SERVICE INFORMATION LETTER NO. SIL20A1-015

Rotax Alert Service Bulletin ASB-912-061R1
ATA-Code: 73-00

Replacement of the pressure side fuel hose at fuel pump part no. 893114 for ROTAX® Engine Type 912 (Series)

Replacement of the pressure side fuel hose at fuel pump part number 893114 for ROTAX® engine type 912 (Series).

Fig. 1
Fuel pump

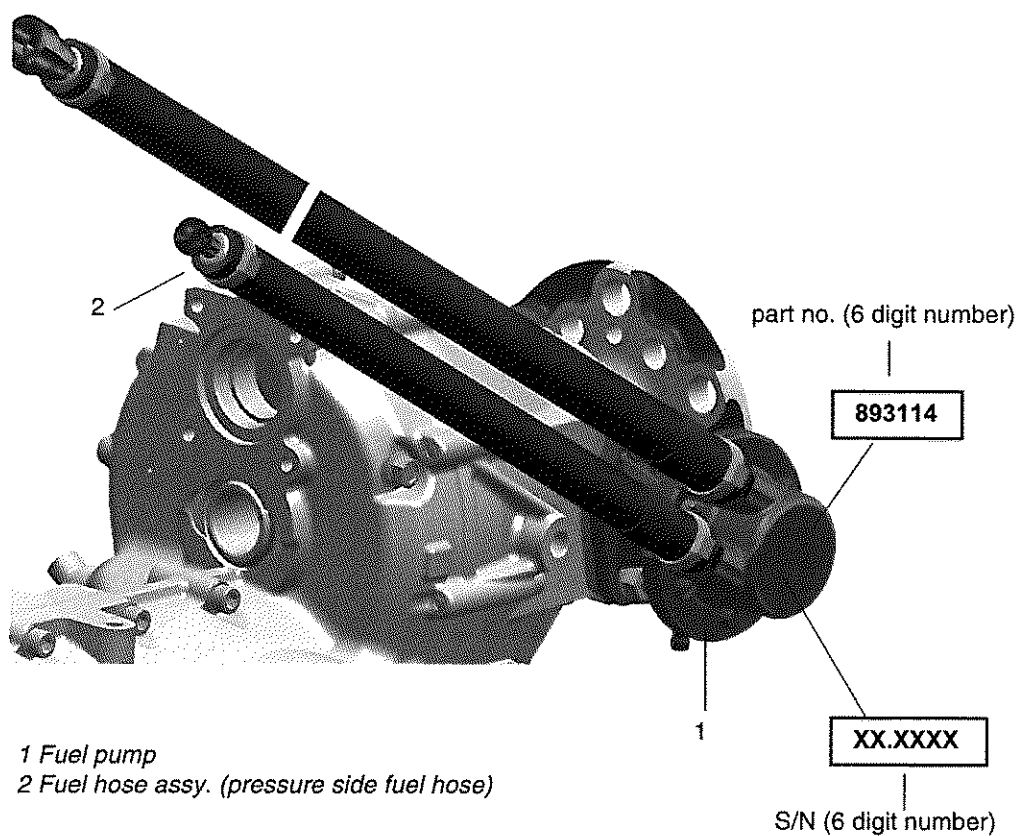
if they are equipped with the genuine ROTAX® fuel pump part no. 893114.
See Fig. 1

Fig. 2
Carburetor, Fuel pump

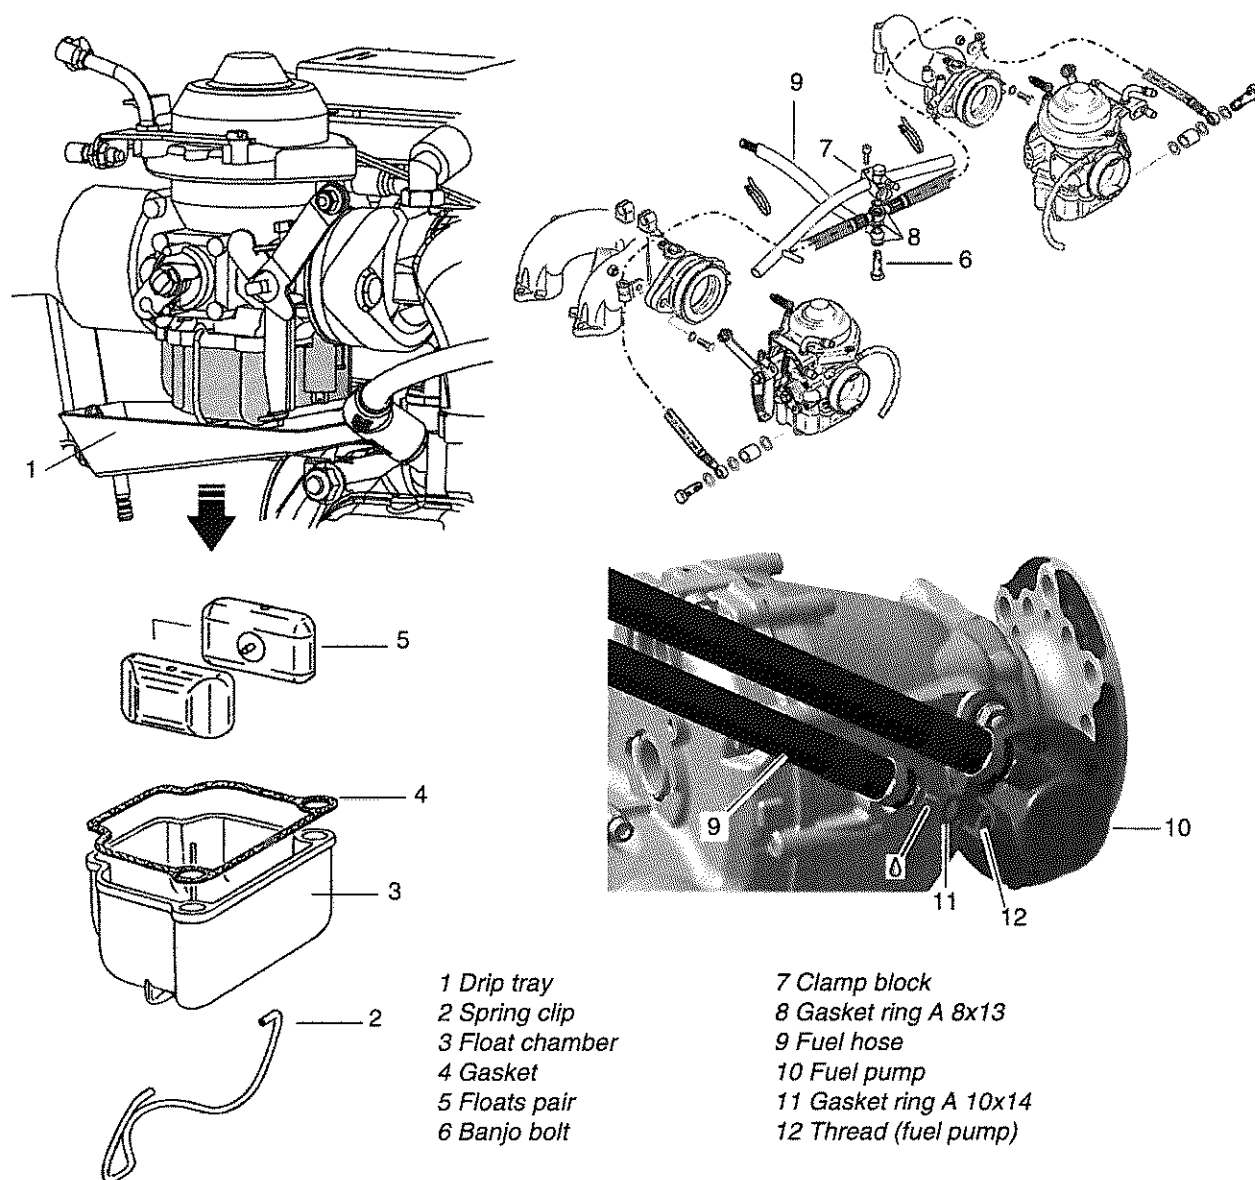
Due to variations in the manufacturing of the fuel hose, rubber particles may become detached.
These particles can interfere or suppress the fuel mixture in the carburetor. This disturbance in the
fuel mixture may lead to rough engine operation, engine misfire and can cause an engine shut
down.

See Fig. 2.

Step	Procedure
1	Remove drip tray (1) - if equipped.
2	Perform visual check on carburetors and its actuation.
3	Open spring clip (2).
4	Remove float chamber (3) including gasket (4) and both floats (5).
5	Check float chamber for contamination.

See Fig. 2.

Step	Procedure
1	Remove banjo bolt (6) from clamp block (7) together with 3 gasket rings (8).
2	Remove the fuel hose (9).
3	Remove the fuel hose (9) from the fuel pump (10) together with gasket ring (11).

Fig. Pos. no.	New part no.	Qty/ engine	Description	Old part no.	Application
2, 9	874336	1	Fuel hose assy.	874335	Fuel pump assy. part no. 893114 (pressure side)
11	250425	1	Gasket ring A10x14	230150	Fuel hose
8	-	3	Gasket ring A8x13/0.8	950143	Clamp block

Step	Procedure
1	Install the new fuel hose (9) and new gasket ring A 10x14 (11) with LOCTITE 243 on the fuel pump. Tightening torque 10 Nm (90 in.lb).
2	Install fuel hose (9) and the banjo bolt (6) with new gasket ring (8) on the clamp block (7). Tightening torque of banjo bolt (6) 10 Nm (90 in.lb). Check that the fuel hose is not under strain or tension.

Bild 1
Kraftstoffpumpe

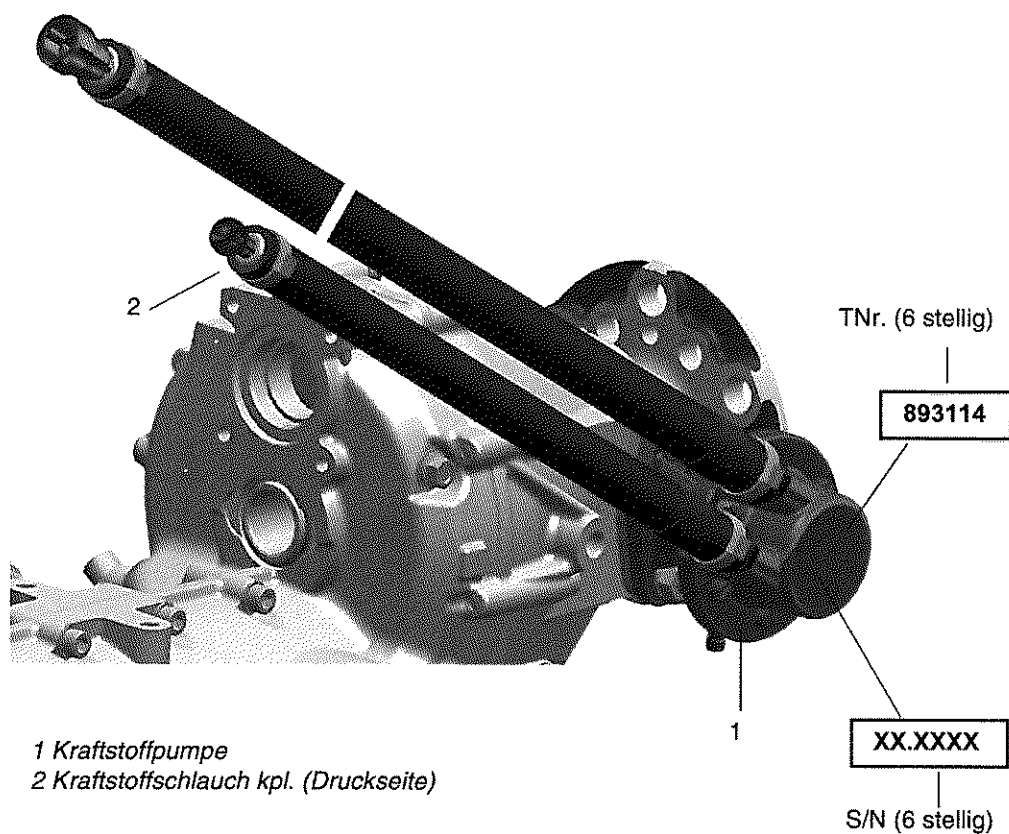
sofern diese mit der ORIGINAL ROTAX® Kraftstoffpumpe TNr. 893114 ausgestattet sind.
Siehe dazu Bild 1.

Bild 2

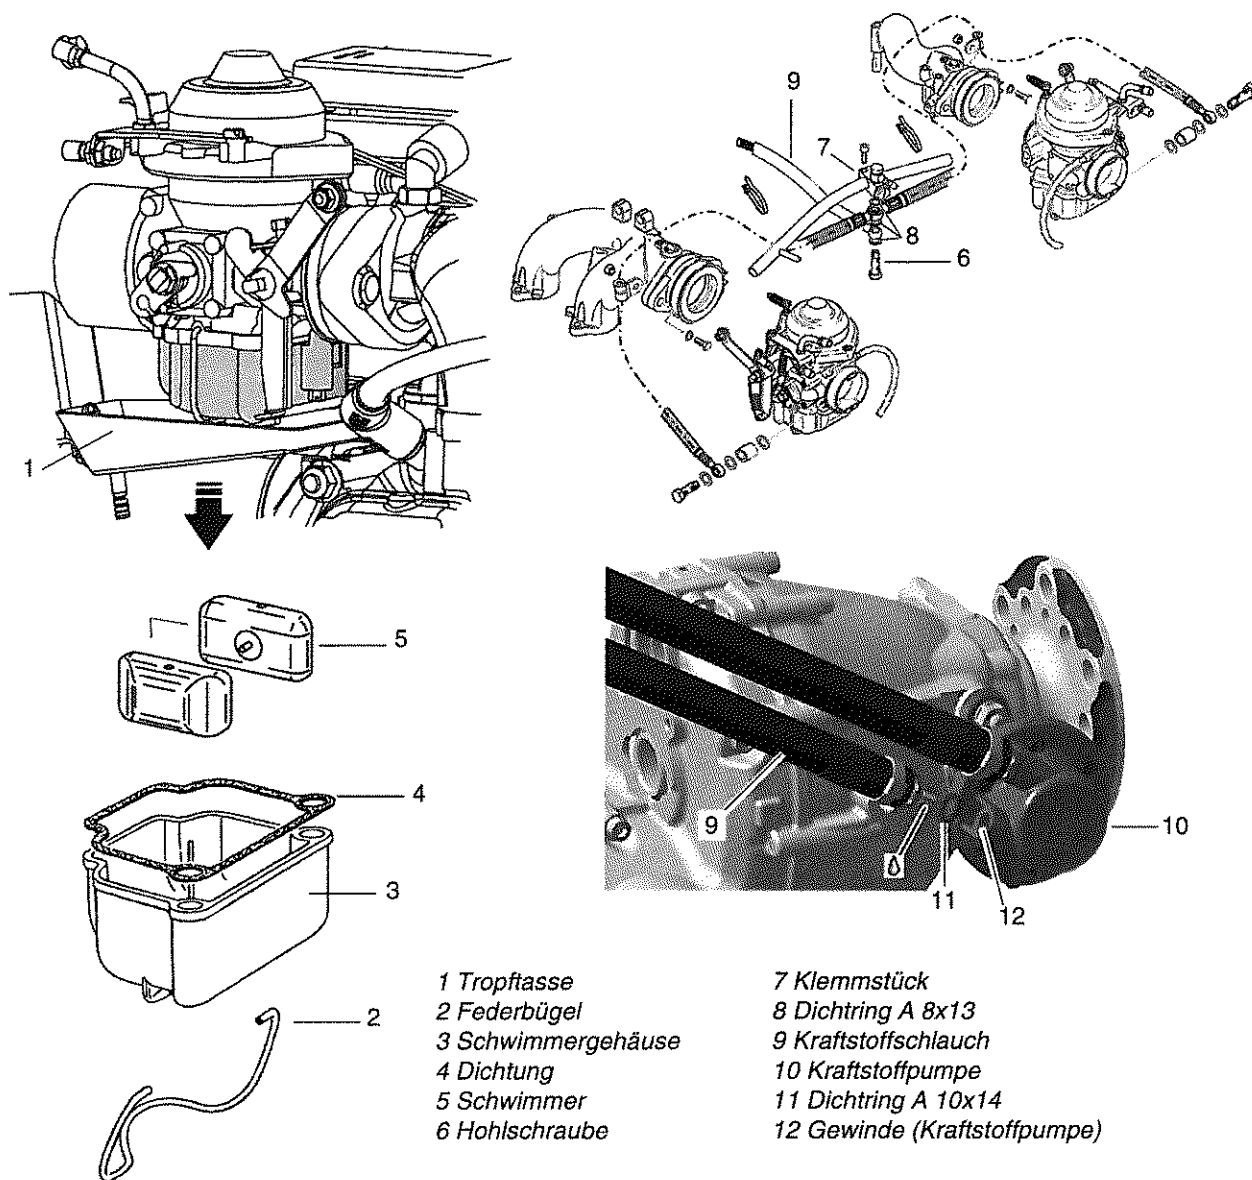
Aufgrund von Abweichungen im Herstellprozess des betroffenen Kraftstoffschlauchs, kann es zu Ablösungen von Gummipartikeln kommen. Diese Partikel können die Gemischaufbereitung im Vergaser behindern bzw. unterbinden. Diese Störung in der Gemischbildung führt unter Umständen zu rauen Motorlauf, Motoraussetzer und eventuell zum Motorstillstand.

Siehe dazu Bild 2.

Schritt	Vorgehen
1	Tropftasse (1) abnehmen-falls vorhanden.
2	Sichtkontrolle des Vergasers und dessen Betätigungen.
3	Federbügel (2) öffnen.
4	Schwimmergehäuse (3) samt Dichtung (4) und die beiden Schwimmer (5) abnehmen.
5	Schwimmergehäuse auf Verunreinigungen kontrollieren.

Siehe dazu Bild 2.

Schritt	Vorgehen
1	Untere Hohlschraube (6) vom Klemmstück (7) abschrauben und samt 3 Dichtungen (8) entfernen.
2	Kraftstoffschlauch (9) abnehmen.
3	Kraftstoffschlauch (9) von der Kraftstoffpumpe (10) samt Dichtring (11) abschrauben.

Bild Pos. Nr.	Neue TNr.	Menge /Motor	Bezeichnung	Alte TNr.	Verwendung
2, 9	874336	1	Kraftstoffschlauch kpl.	874335	Kraftstoffpumpe kpl. TNr. 893114 (Druckseite)
11	250425	1	Dichtring A 10x14	230150	Kraftstoffschlauch
8	-	3	Dichtring A 8x13	950143	Klemmstück

Schritt	Vorgehen
1	An der Kraftstoffpumpe den neuen Kraftstoffschlauch (9) mit LOCTITE 243 sichern und mit einem neuen Dichtring A 10x14 (11) montieren. Anzugsdrehmoment 10 Nm.
2	Kraftstoffschlauch (9) spannungsfrei verlegen und mit Hohlschraube (6) samt neuen Dichtringen (8) am Klemmstück (7) montieren. Anzugsdrehmoment der Hohlschraube (6) 10 Nm.
